Agenda
Planning Commission
Wednesday, 16 May 2018 – 7:00 P.M.
City Hall-Council Chambers, 1 S Huron St
Ypsilanti, MI 48197

**Staff Review of Site Plan Application
Cultivate Coffee & Taphouse
307 N River**

Regarding: Cultivate Coffee & Tap House
Site Plan Review No. 1
OHM Job No. 0094-18-1030

SHEET + NUMBER
SP1.00

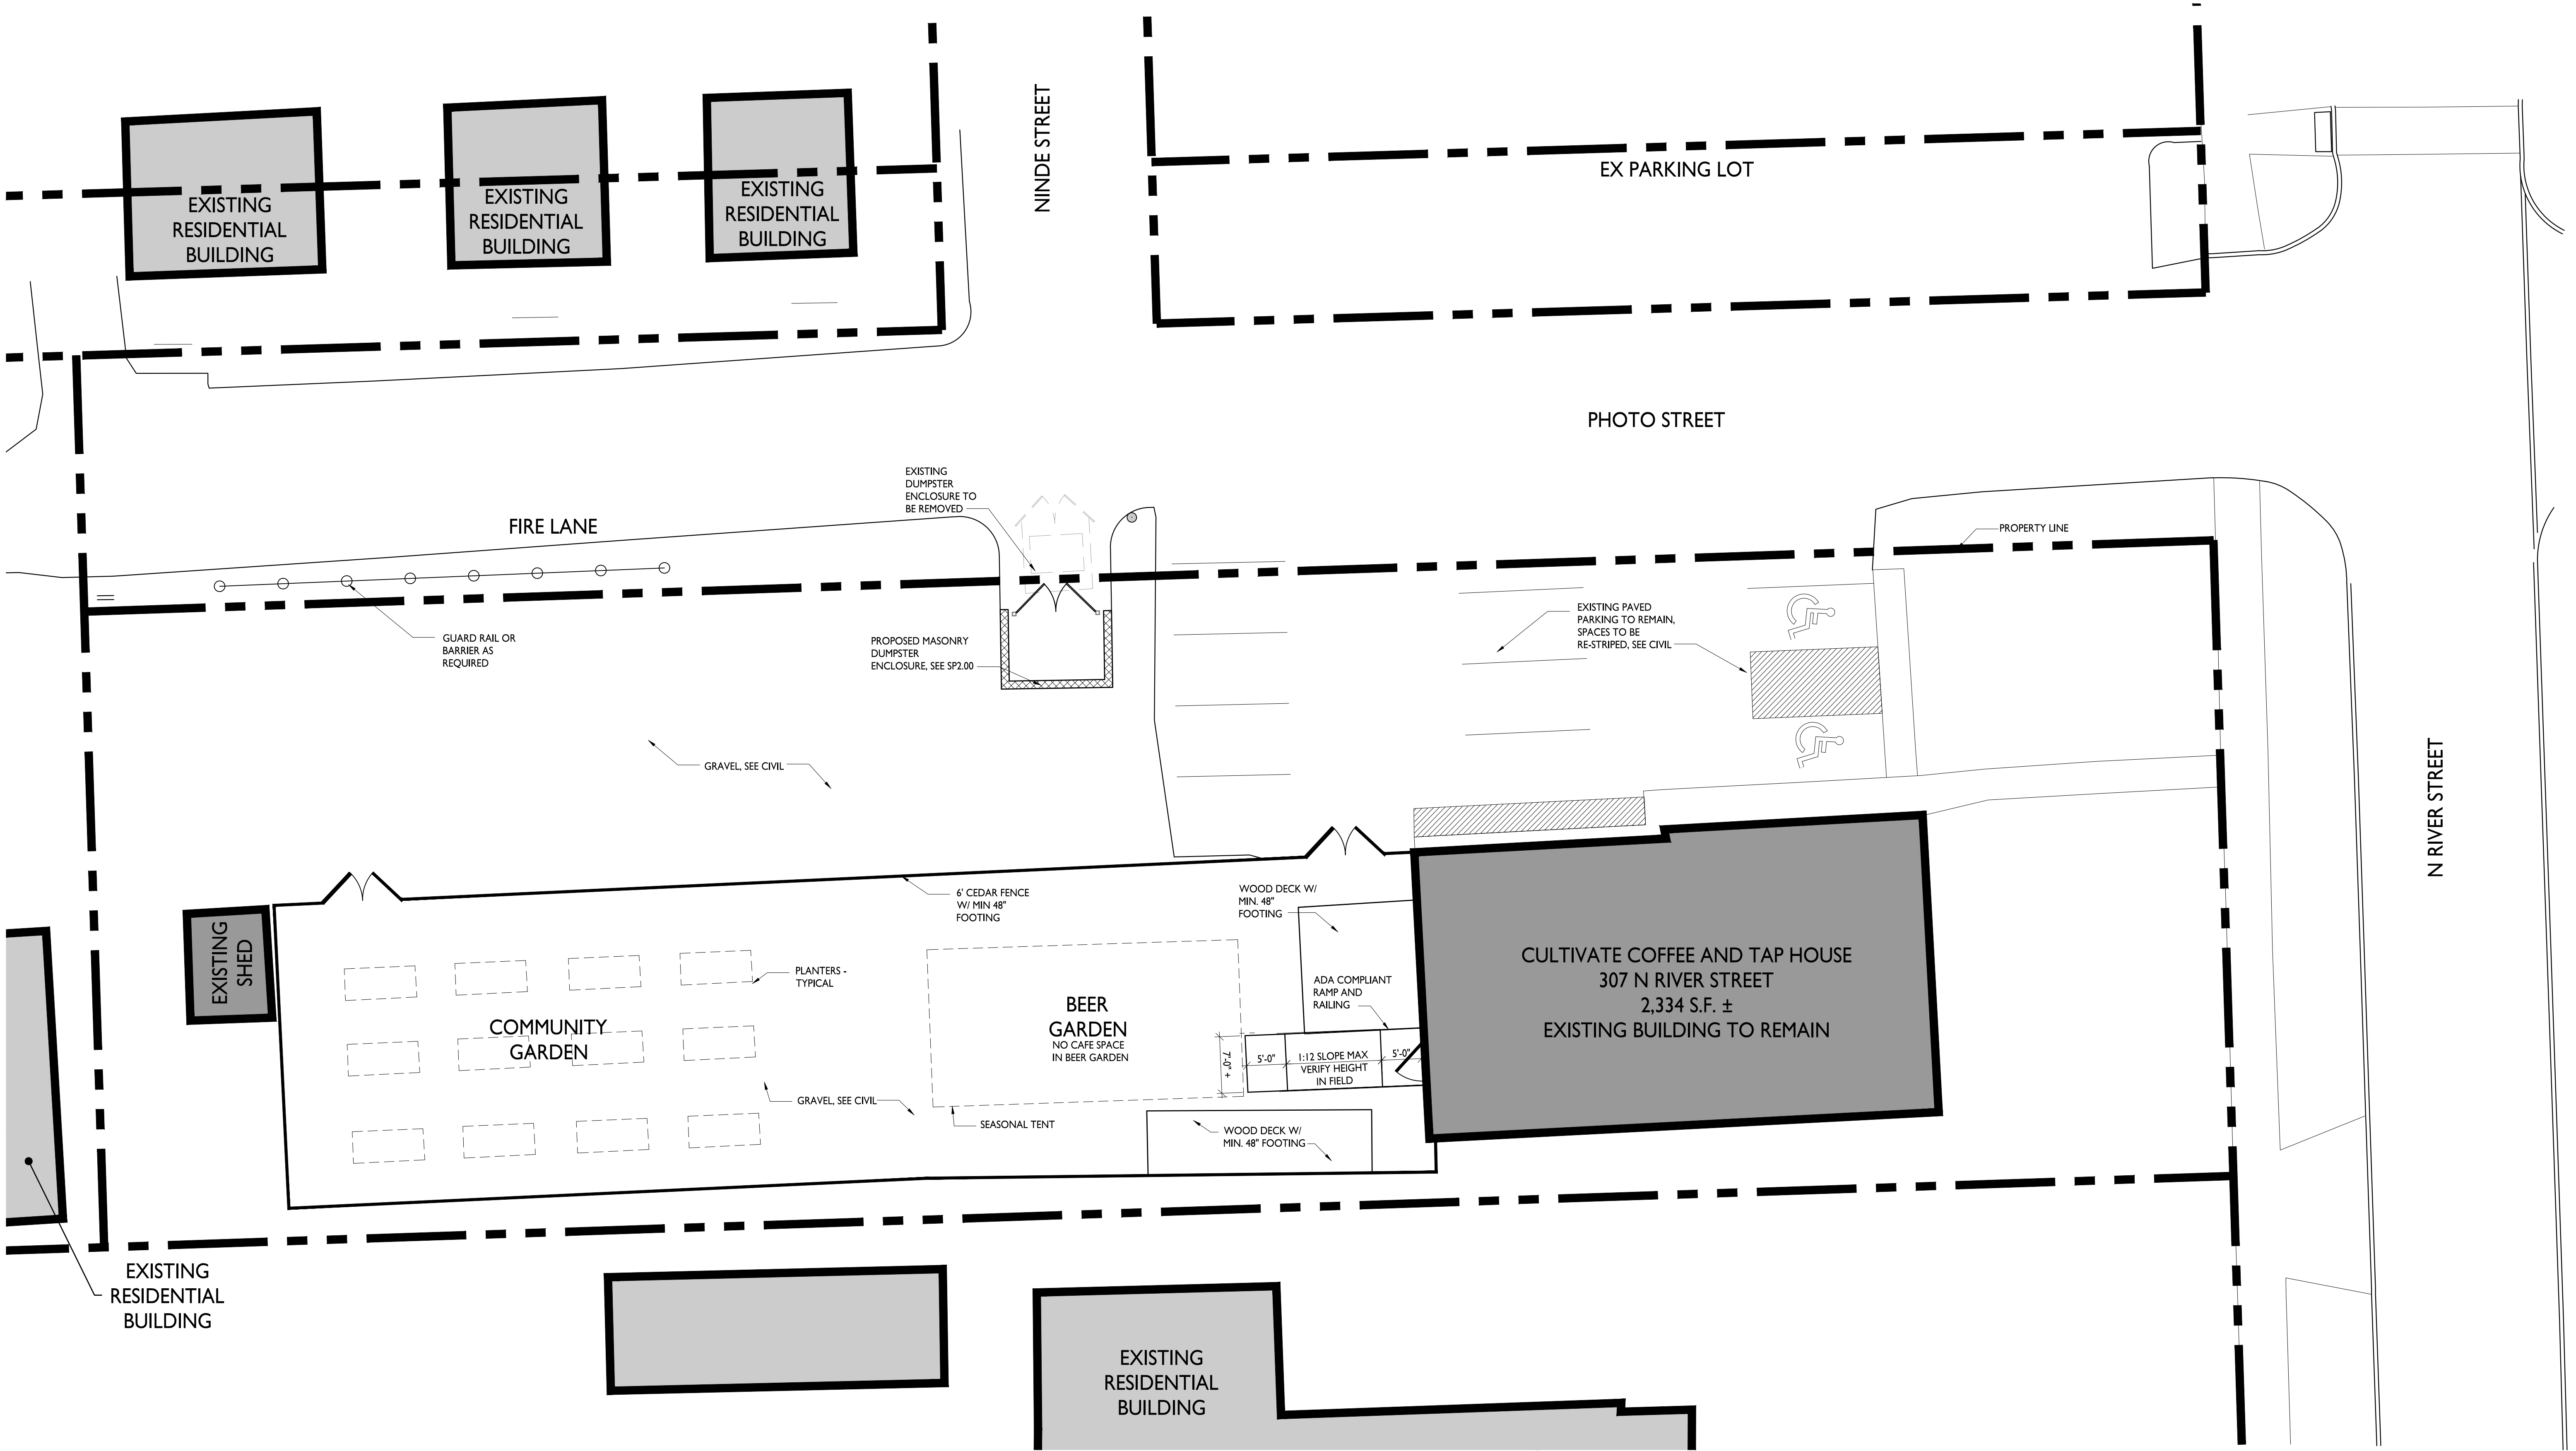
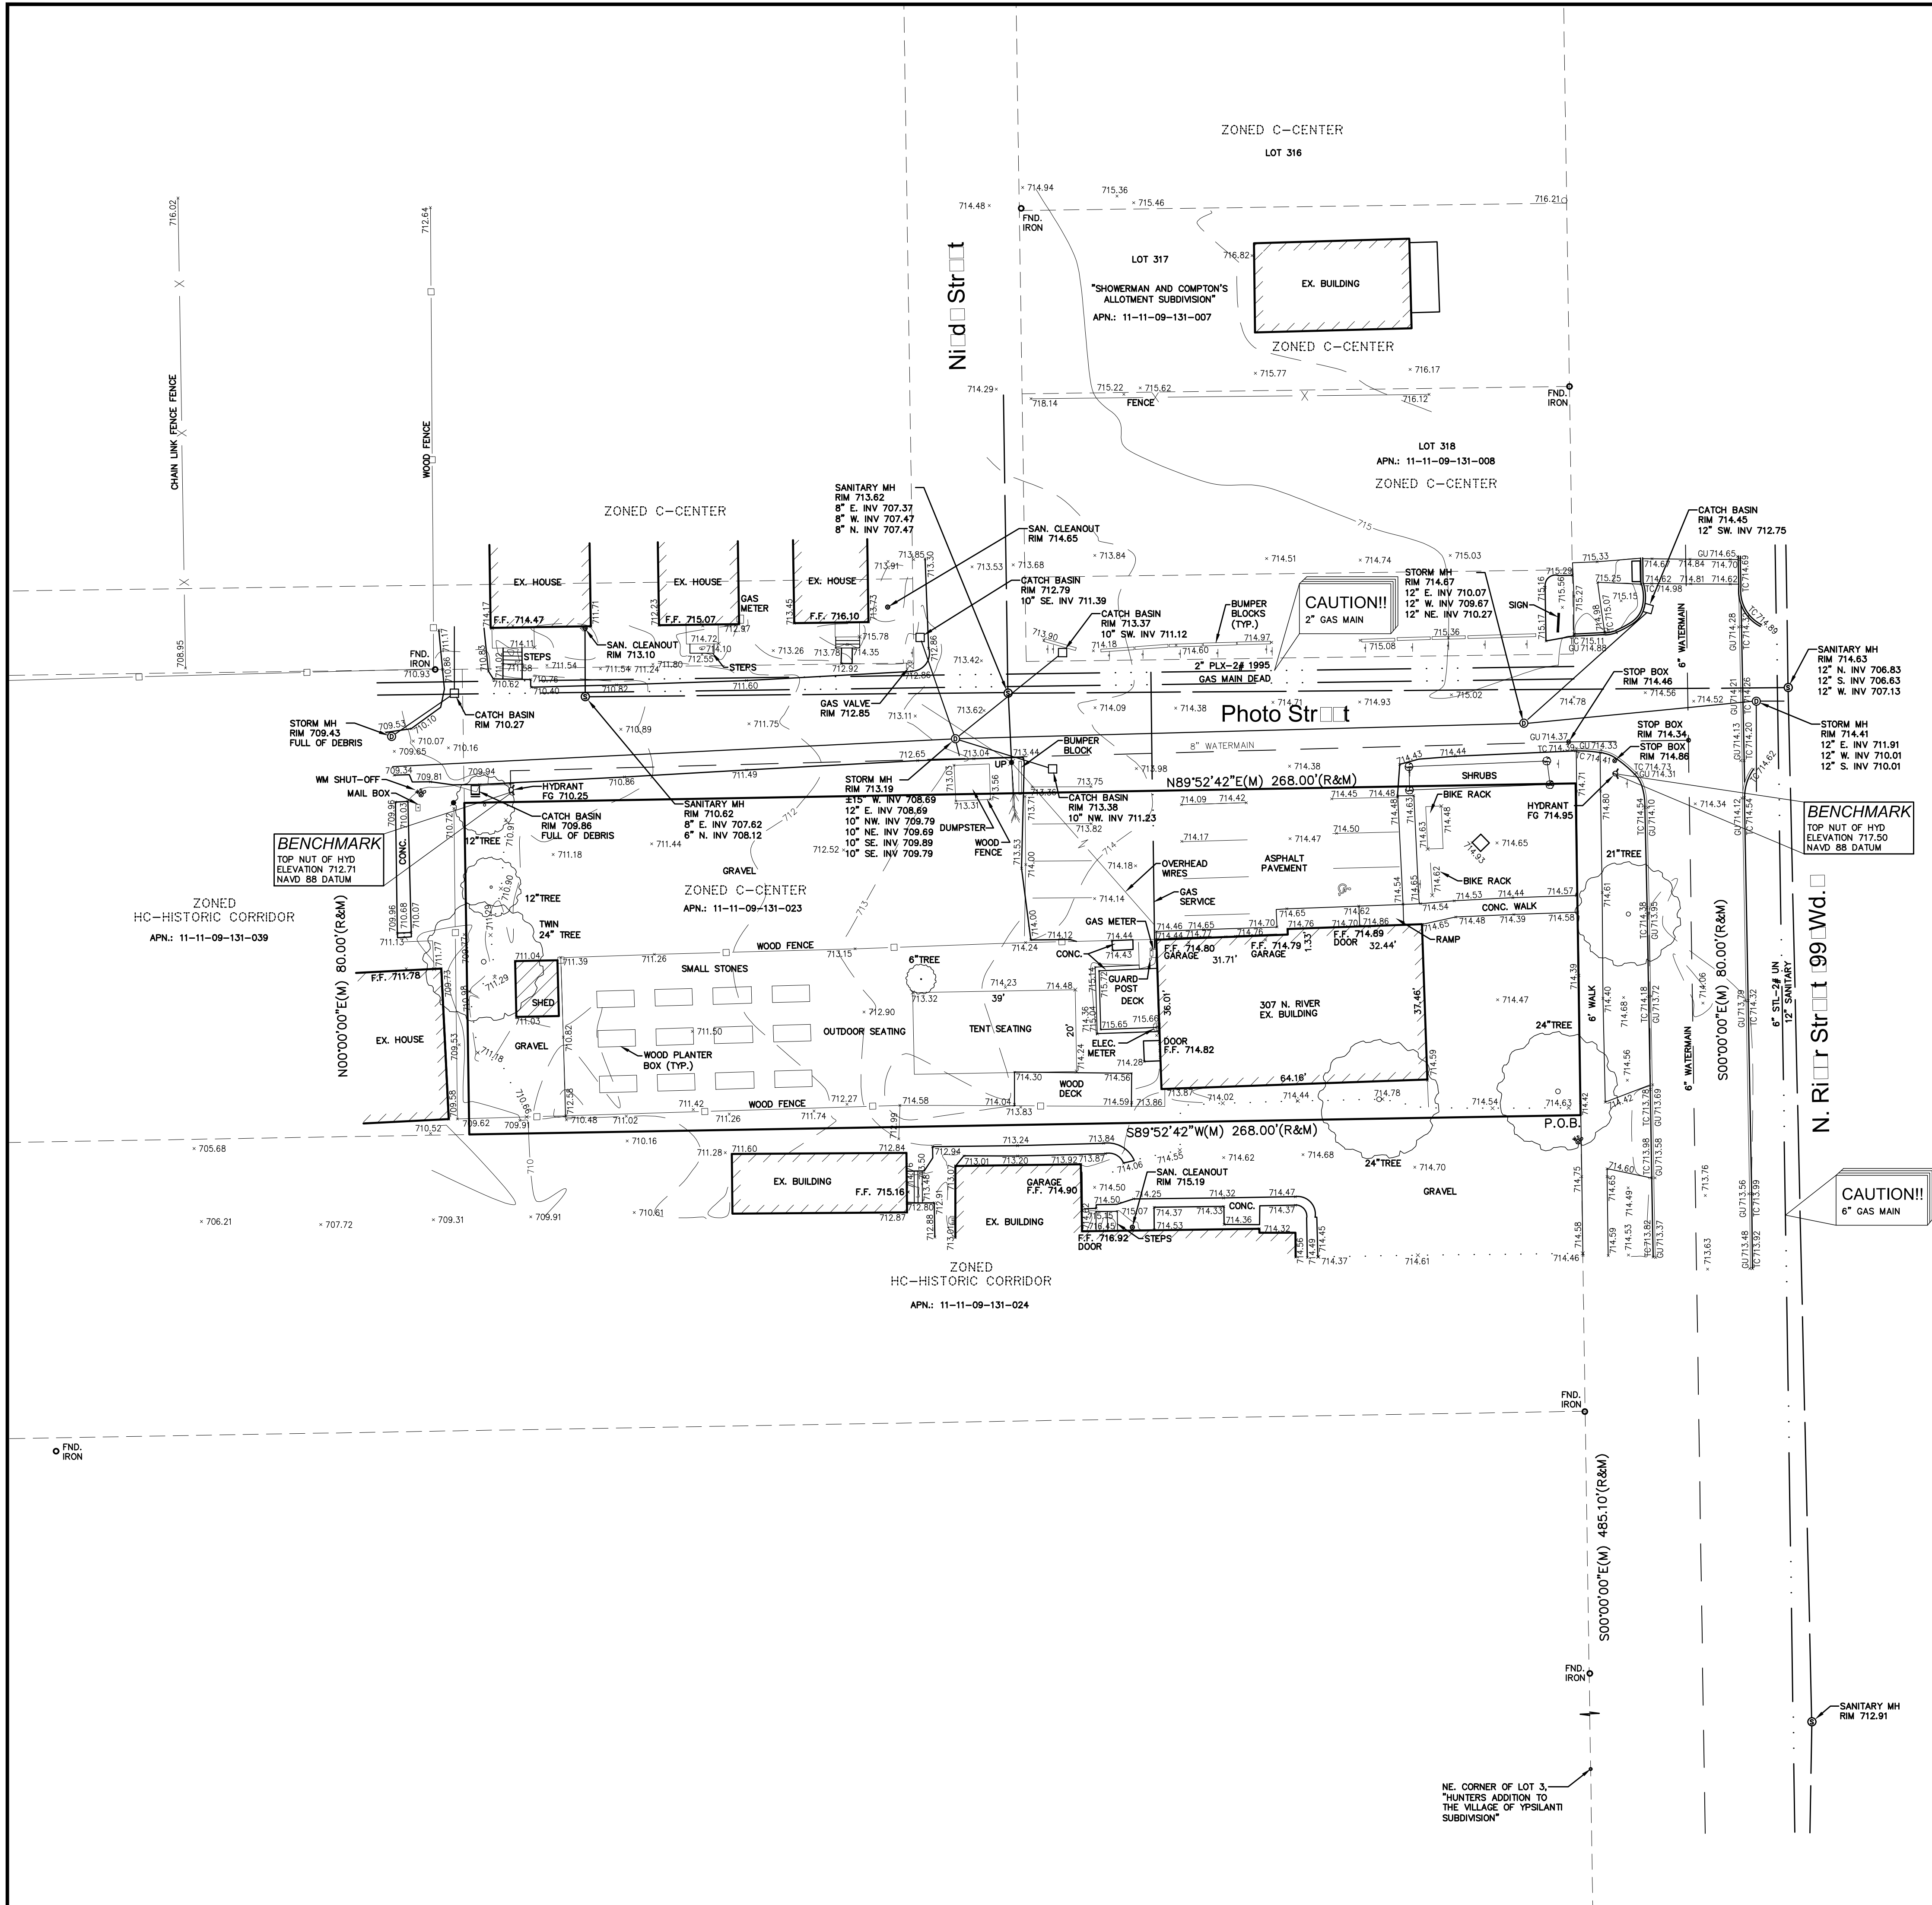
Items to be Addressed: Applicant to note the requirement "all outdoor areas shall be kept clean and void of litter at all times" on site plan.

- No count or rough dimensions given for gravel parking area. Applicant to provide.
- Parking lot access is less than 50' from Ninde/Photo intersection. Applicant to revise.
- No lighting is shown on the plan. Applicant to show either site lighting or adequate street lighting.
- Two trees required.
- Parking aisles in paved area are unprotected by islands.
- Parking (both gravel and paved) is not screened from Photo.
- No sidewalk provided along Photo. Planning Commission waiver for fee-in-lieu requested.
- Dumpster is within the visibility triangle for the gravel parking. Applicant to revise entrance to gravel parking.
- Conflicting land use screening is required between the gravel parking and the residential use to the west.

ORDINANCE REFERENCE	REQUIRED	EXISTING CONDITIONS	PROPOSED
§122-609 Lighting	• Dark Sky compliant; may be full cutoff where affecting residential uses • not >0.5 fc @ lot line • not >16'in height • not < 0.3 fc		No lighting proposed. Show cut sheets and locations for all proposed site lighting.
§122-608 Refuse Containers	Not located in the front yard or street side yard (waiver available) Maintained in a neat, orderly, and sanitary condition Adequate vehicle access must be provided masonry enclosure 1' taller than dumpster (no less than 6'), in rear yard, 80% opaque swing door	Dumpster in wooden enclosure	Applicant shows a dumpster in the street side yard. Waiver requested as no other location with vehicular access is available, due to unique condition of Photo / Ninde.
§122-631 Landscape plan			None provided.
§122-634 Screening Between Land Uses <i>if conflicting use</i>	visual buffer of at least 80% opacity and 6' height		Required between Cultivate and properties to south and west. Gravel parking lot conflicts with residential use to west, screening must be provided.

§122-636 Street Trees	1 tree per 30' of lineal frontage, centered between sidewalk and back of curb: 80'/30' = 6 trees		River: 3 trees required. One tree present, with extensive canopy. Waiver of one tree requested; applicant to plant one additional tree. Photo: no street trees provided. Applicant requests a waiver.

- If outdoor lighting proposed, applicant to indicate on site plan and submit cut sheets.
- Waiver requested per 122-608(a) to allow placement of dumpster in street side yard, due to maneuverability challenges.
- Applicant to provide conflicting land use screening between gravel lot and property to west.
- Waiver from street tree requirement for one tree (of two) requested on River; waiver from street tree requirement on Photo for nine trees (of nine) requested.

- If outdoor lighting proposed, applicant to indicate on site plan and submit cut sheets.
- Applicant to note the requirement “all outdoor areas shall be kept clean and void of litter at all times” on site plan.
- Applicant to address the following issues regarding the graveled parking area:
 - Lack of screening from Photo Street.
 - Lack of lighting. If on-site lighting is to be provided, please show in plan. If public street lighting is sufficient, please document.
 - Dumpster enclosure is within the visibility triangle of the parking lot entrance.
 - Conflicting land use screening is required between the parking area and the property to the west.
 - Provide approximate count of spaces proposed in gravel parking area.
 - Parking lot access is less than 50’ from Ninde/Photo intersection. Applicant to revise.
